# A G E N D A

## Architectural Review Board

September 28, 2021 – 5:30 p.m.

1A

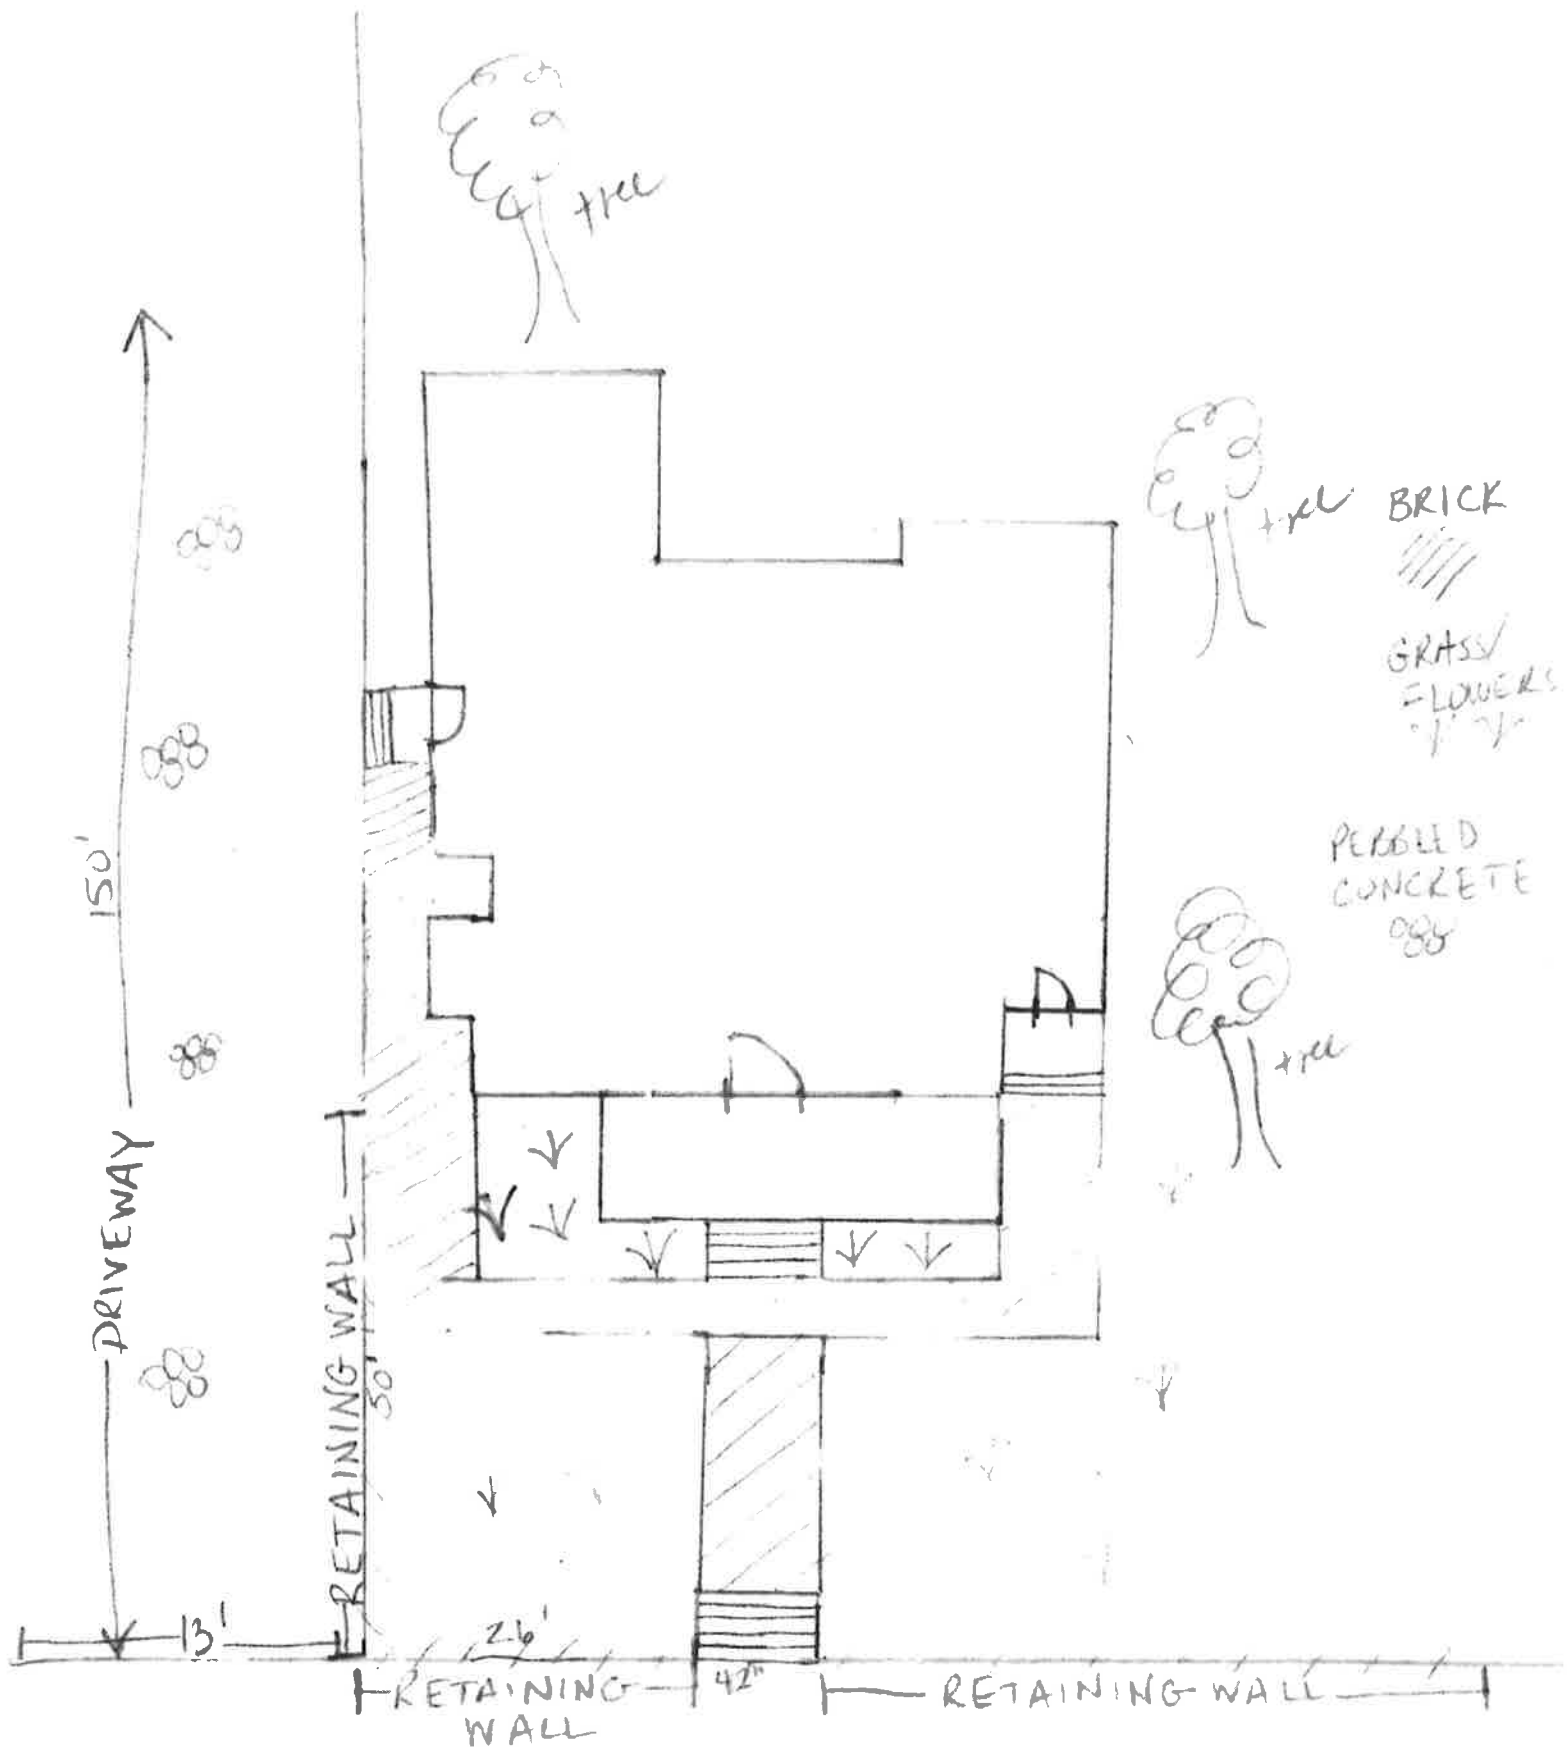
- Grade change is less than adjacent property photographed as an example, 5 steps may not be required.
- No objection

1942 Graham St

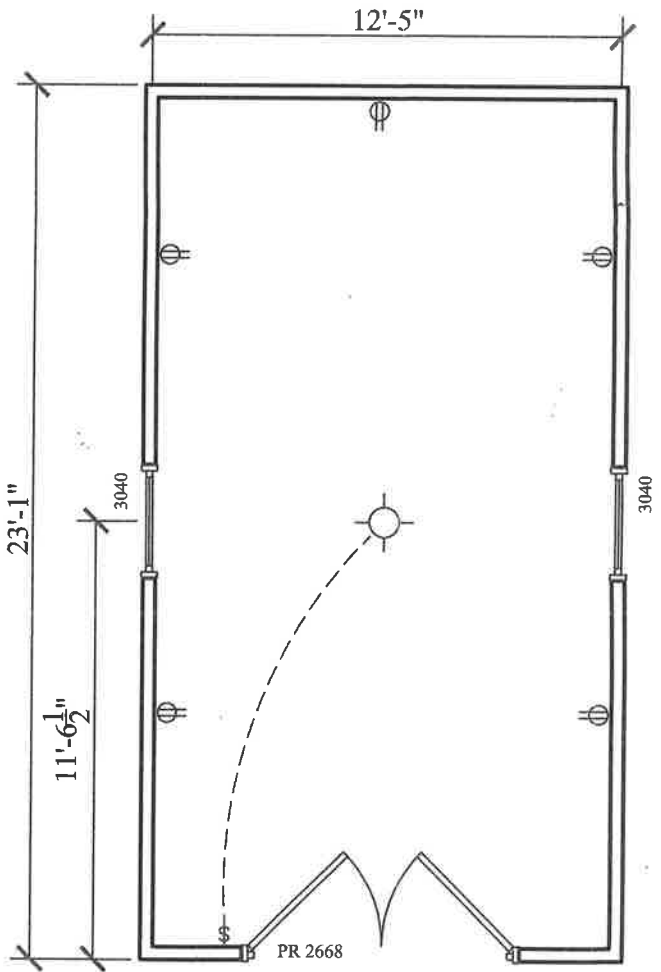
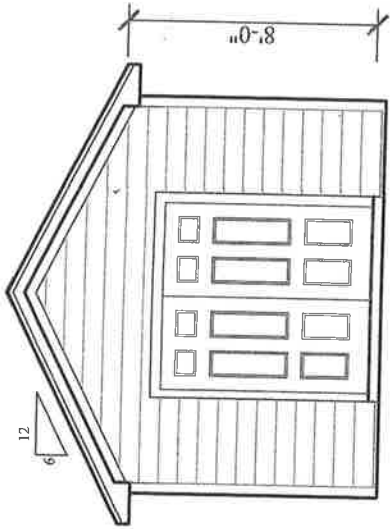
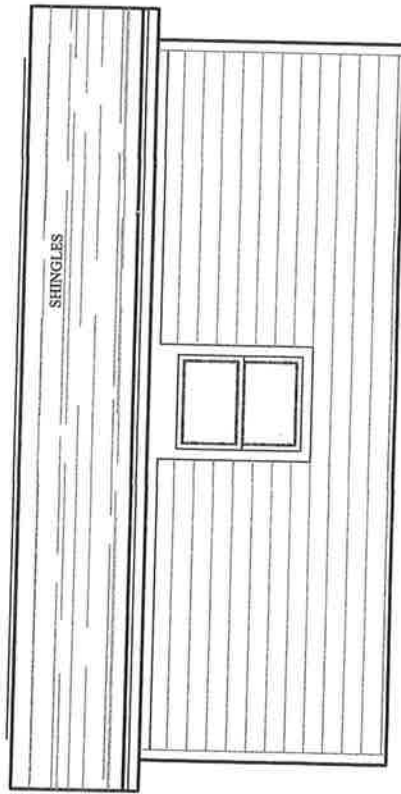
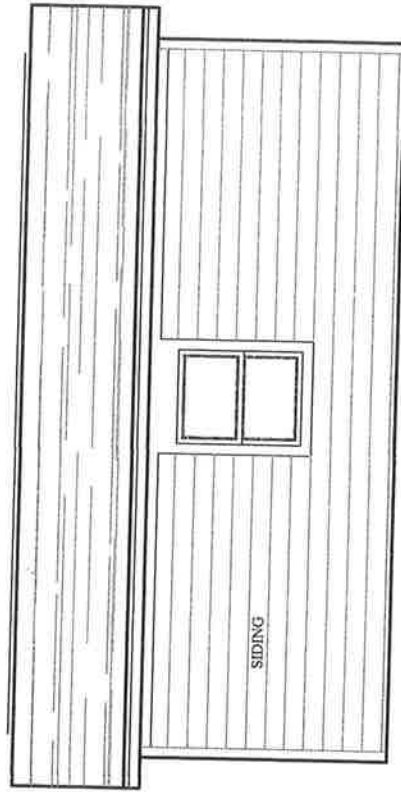
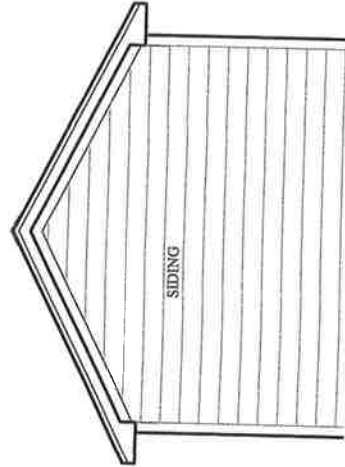
- The Board has allowed the use of composite and synthetic materials on new shed type outbuildings—all materials proposed are approvable under the expedited shed review process, this building is larger than what staff can approve.

From Table 9 for T4-C

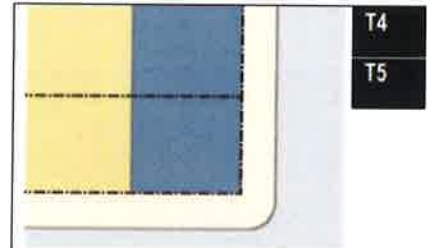
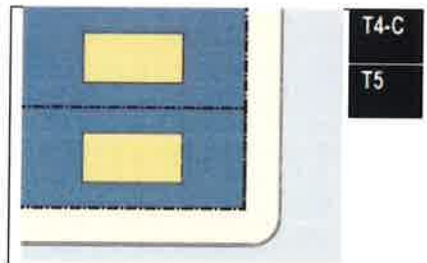
- Smart Code 5.5.1e: Facades shall be built parallel to the principal Frontage Line (*in this case Herron St*) or parallel to the tangent of a curved principal Frontage Line. Proposal does not conform to zoning regulations.

- Smart Code 5.5.1f: Setbacks for principal buildings shall be as shown in Table 14F (see above). Proposal does not conform to zoning regulations.
- It has been the contention of staff that the focus should be in the direction of the neighborhood and not the interstate to maintain an edge against encroachment of a vehicle intensive nature. The layout as proposed embraces the interstate.

**A. STREETSCREEN**

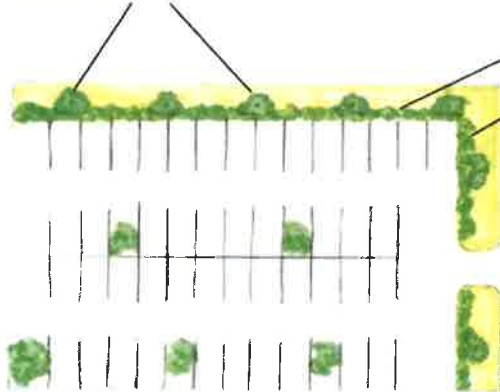
- In order to review the landscape plan/tree replacement plan for smart code compliance, the project will need to meet site layout requirements. Smart code landscaping is directly affected by the building frontage and parking orientation. Until that is addressed, I cannot review this project any further than directing the submitter to the Smart code requirements for the site, and from there to the Smart code landscape requirements relating to the site requirements.
